12/2019/0912

APPLICATION NO: 12/2019/0912/ PO

PROPOSAL: Development of 0.14 ha of land by the erection of 3 no. detached dwellings (outline application including access)

LOCATION: Land opposite Ty Newydd Clawddnewydd Ruthin

Existing and Proposed Site Elevations & Sections

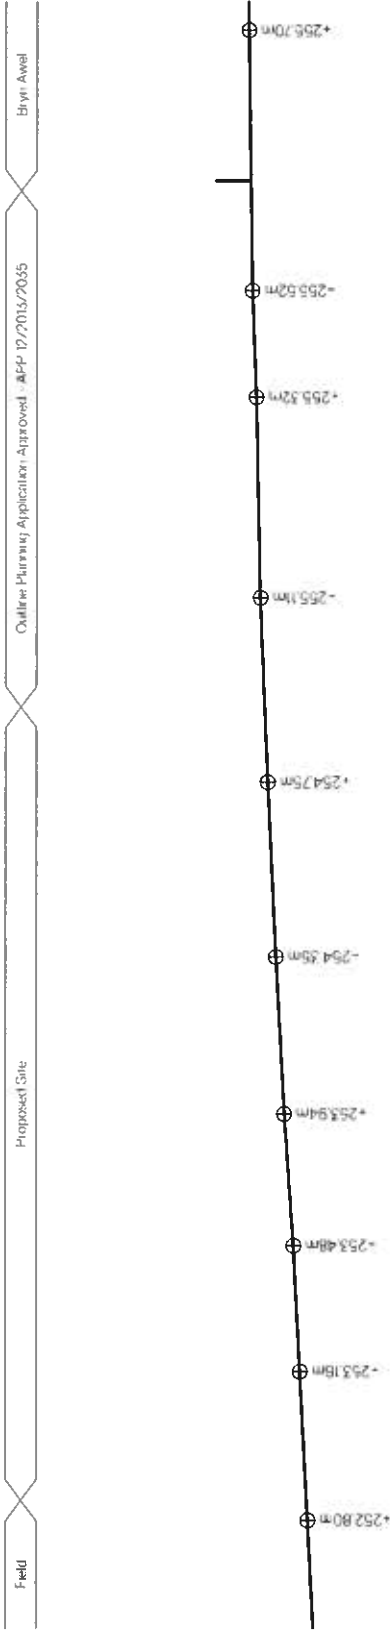
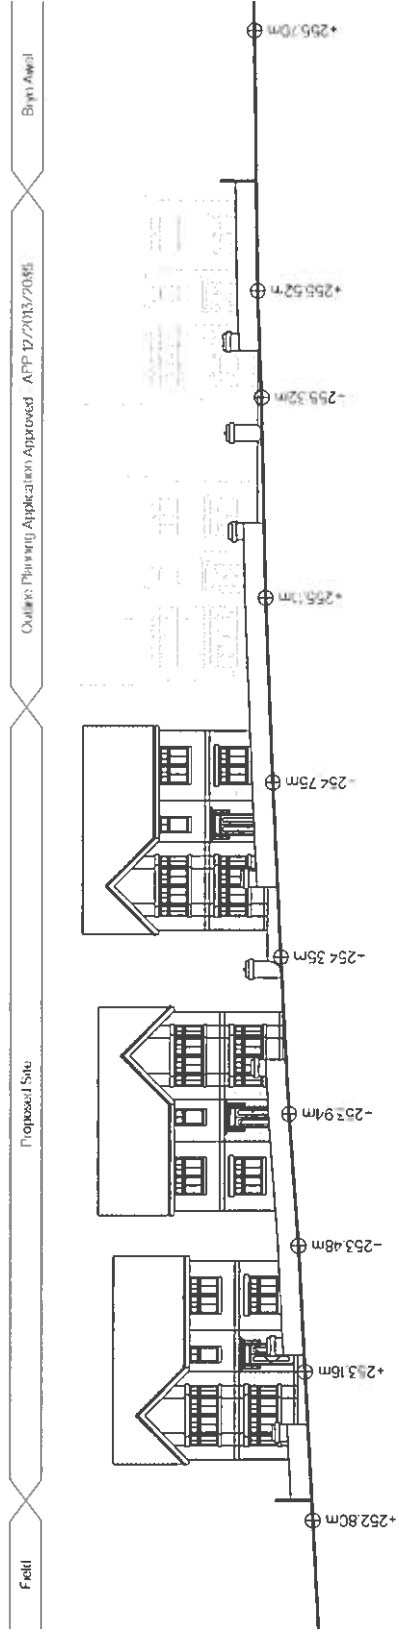
The Community Council has raised concerns relating to the highway entrance to the properties and they consider this should only be considered on the B5105 on the Ruthin Road and not on the unclassified road to Clocaenog as proposed.

The means of access to the site is included for approval as part of this outline application and it is proposed to construct a shared access off the unclassified road to Clocaenog. The proposed plans show how the access would be detailed and how additional land has been included to allow for improved visibility at the point of entry into the site.

- (iii) Existing and proposed site elevations and sections (Drawing No. A007 Rev. P01) received 23 October 2019
